TDK Corporation

Process Change Notice**Notification for Dummy Pattern Abolish for Chip NTC Thermistors**

2. Dummy pattern abolish and target products**3. Schedule**

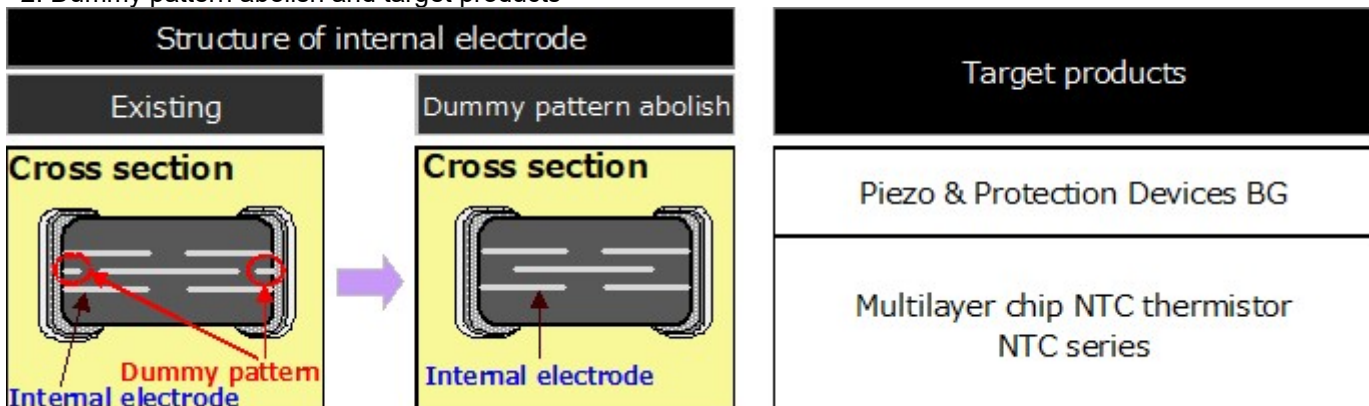
In response to the recent trend of increasing global demand for palladium,
 we have decided to abolish the dummy pattern that do not affect product characteristics,
 in order to ensure a stable supply of our chip NTC thermistors.

There is no change in product name, specifications (appearance, dimensions, electrical characteristics),
 reliability, process control plan, etc.
